DOCKET 50-255 - LICENSE DPR-20 - PALISADES NUCLEAR PLANT
WITHDRAWAL OF RELIEF REQUEST TO PERFORM WELD OVERLAY REPAIRS
ON CONTROL ROD DRIVE MECHANISM (CRDM) UPPER HOUSINGS; AND
RESTATEMENT OF RESPONSES CONCERNING WELD NO. 1 (TAC NO. MB3001)

**Response to Request for Additional Information Regarding Weld No. 1 (Reactor
Vessel Head Nozzle Pipe to Flange Weld) as provided November 6, 2001**

**Follow-up Questions Regarding Weld No. 1 (Reactor Vessel Head Nozzle Pipe to
Flange Weld) as provided November 17, 2001**

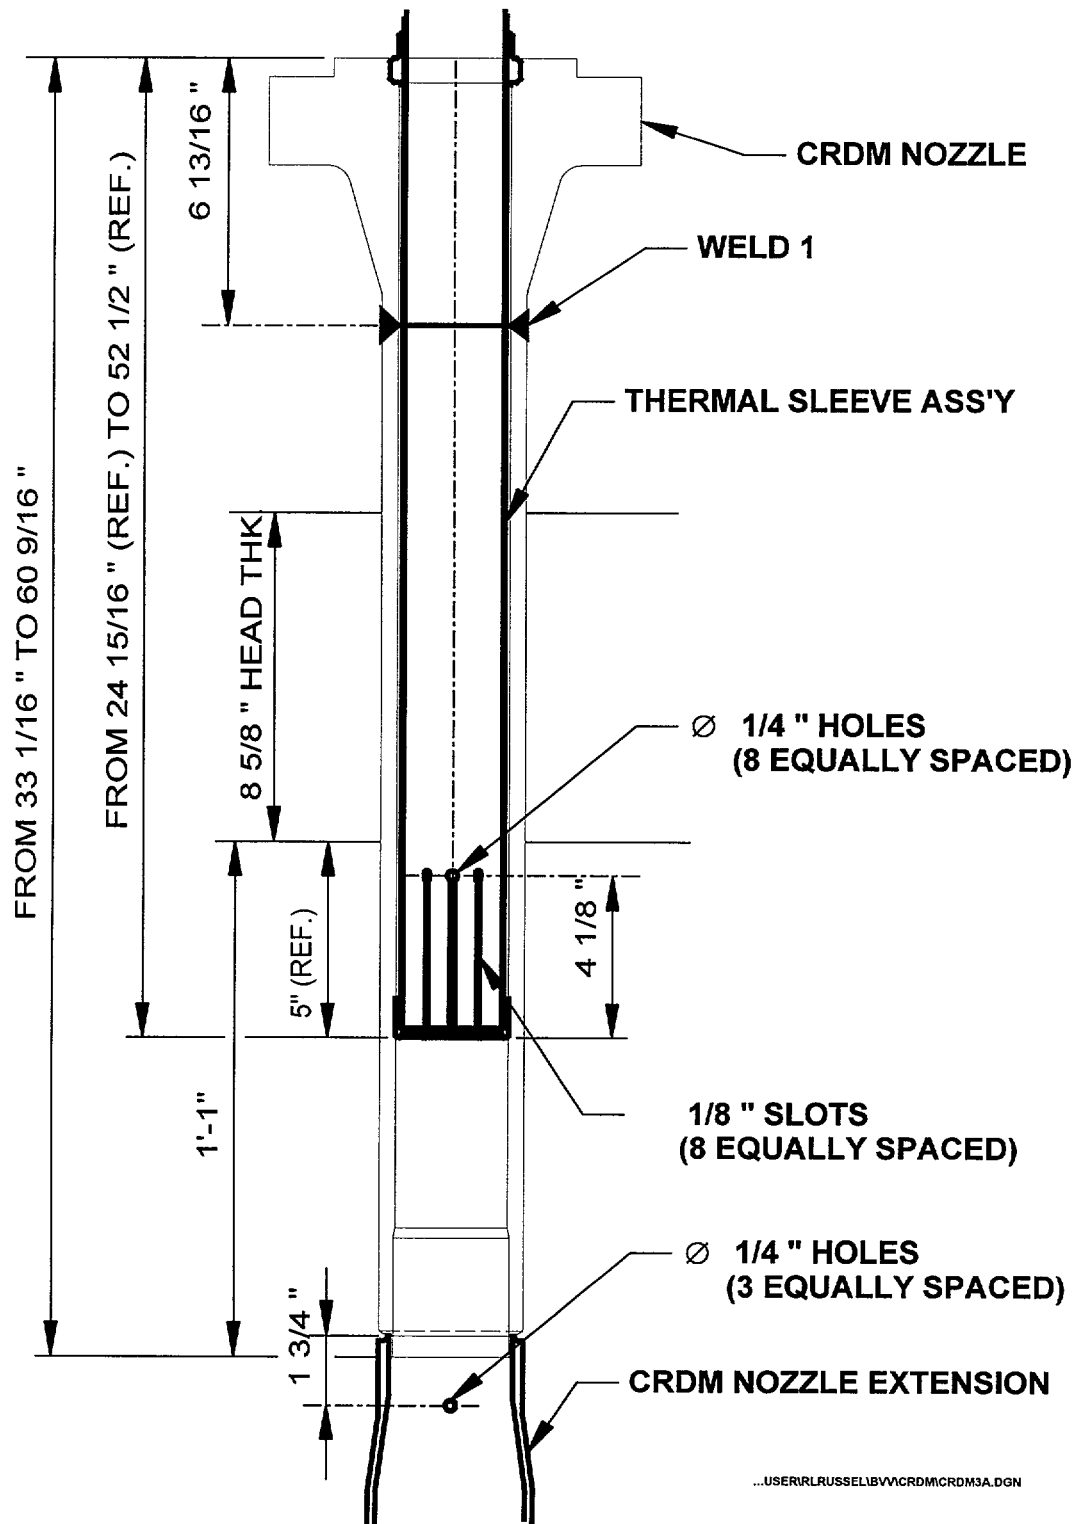
Regarding the holes in the thermal sleeve, provide a sketch showing their location relative to Weld No. 1. It is not apparent why there would be flow in the thermal sleeve annulus in the vicinity of Weld No. 1.

The attached sketch shows the location of flow holes. The subject flow holes are not in the thermal sleeves themselves. The three ¼ inch diameter flow holes exist within each CRDM nozzle tube assembly. They are located about 13 inches from the inside of the reactor head. Due to the presence of the upper guide structure between the fuel and the nozzle tube ends, a portion of the reactor coolant flow proceeds upward into the nozzle tube assemblies and out of the three ¼ inch diameter flow holes. In addition to this, a temperature gradient exists between the inside of the thick vessel head and Weld No. 1. This temperature gradient will promote some convective flow within the annulus surrounding the thermal sleeve as would occur in any environment where a temperature gradient exists.

Although the flow between the two scenarios is limited, fluid exchange will occur at some rate within the annulus, causing residual oxygen (from vessel fill) to be lessened within the annulus.

Weld Number 1

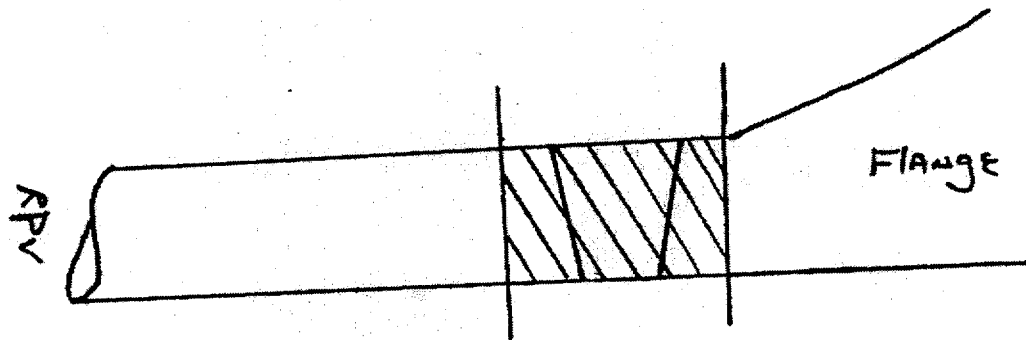
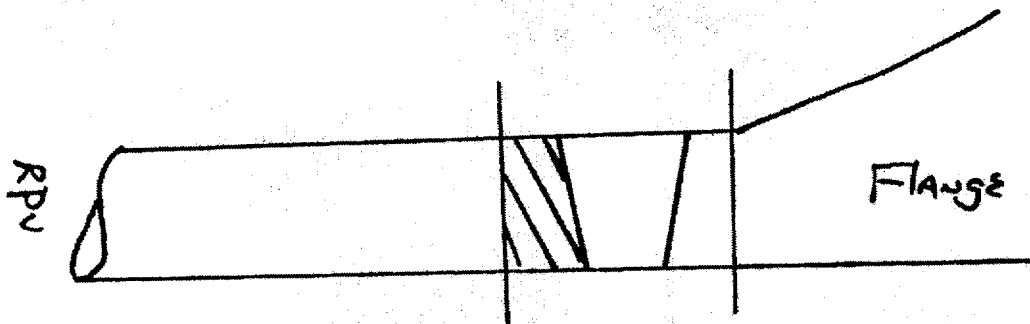
Provide a cross-section of the weld showing the volume that was inspected using qualified procedures and personnel. Show the volume that was inspected using a best effort UT procedure and personnel:

See the attached sketch.

\ = Axial
— = Circumferential
